Addendum No. 1

Owner: City of Unalaska

Project: **SUMMER BAY ROAD BRIDGE REPLACEMENT**

Date: February 11, 2014

enc: Sheet C-4 Bridge plan and profile
Sheet C-5 Bridge section detail

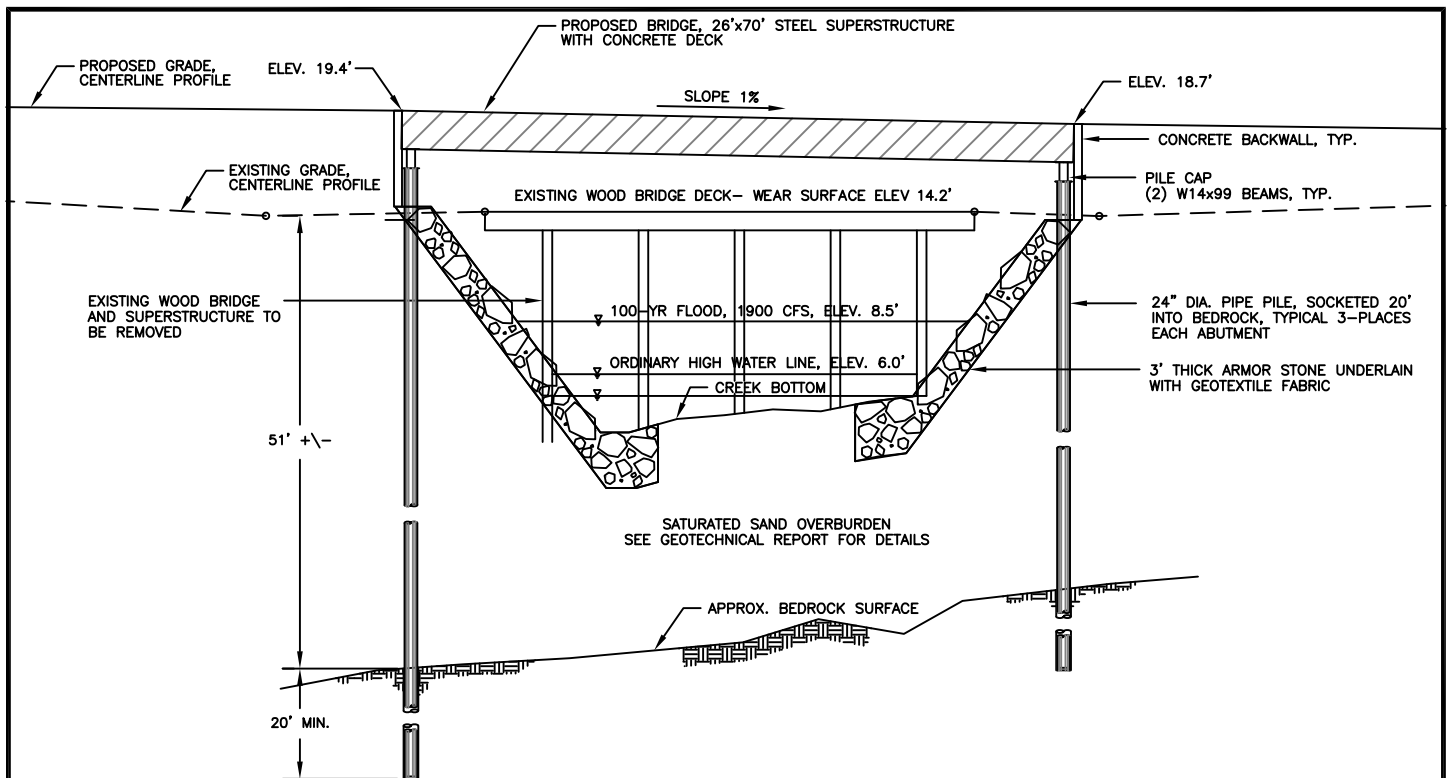
Item 4: DESIGN DRAWINGS, Sheet C-4 of 11 ROAD AND BRIDGE PLAN AND PROFILE;

Replace drawing C-4 in its entirety with the attached revised drawing C-4. There were changes to the called out bridge dimension, the extent of the guardrails, the extent of the silt fence, and the limits of fill at the guardrail end sections.

TITLE: **GUARDRAIL DETAILS**

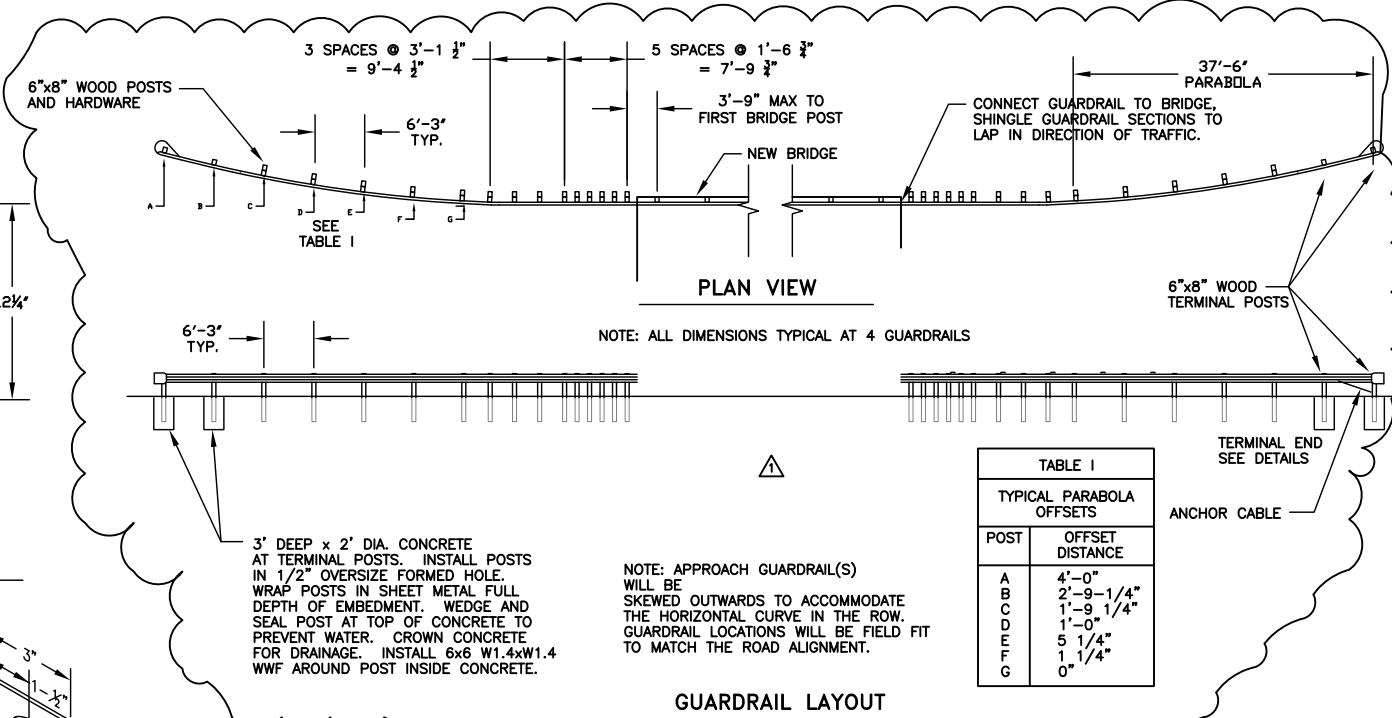
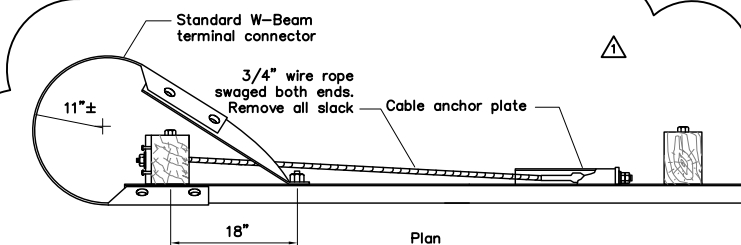
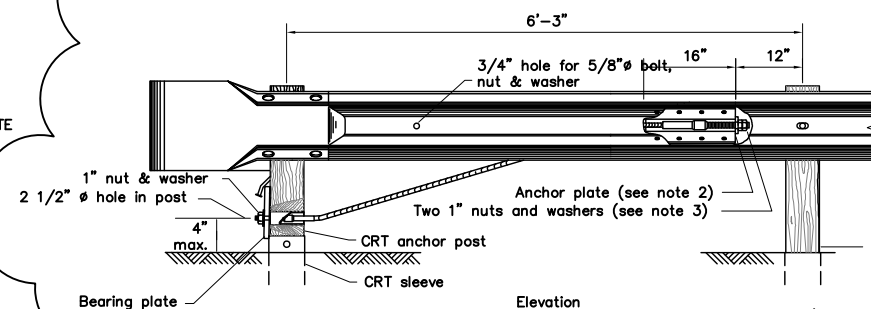
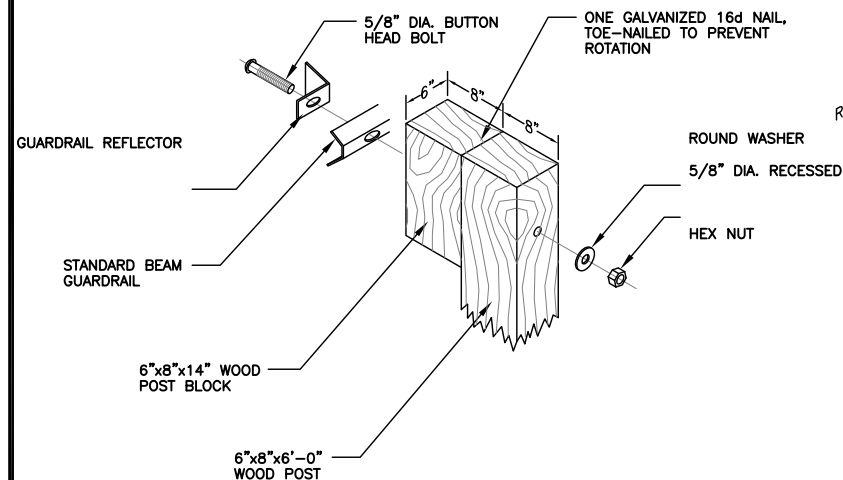
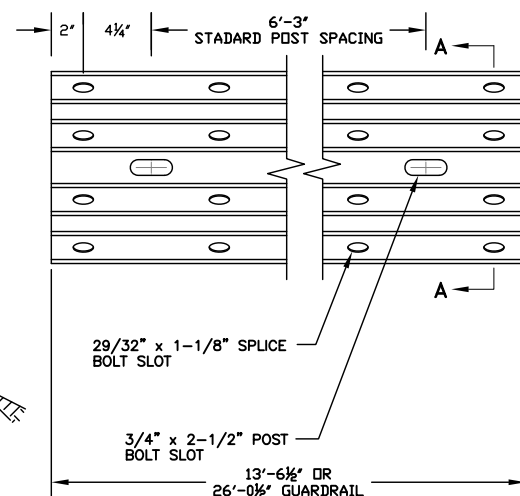
Item 5: DESIGN DRAWINGS, Sheet C-7 of 11 GUARDRAIL DETAILS;

Delete drawing C-7 and replace it with the revised attached drawing C-7.

REV	DATE	DESCRIPTION
1	02/13/14	ADDENDUM 1, DIMENSIONS, GUARDRAIL, SIGNS
0	01/24/14	FOR BID
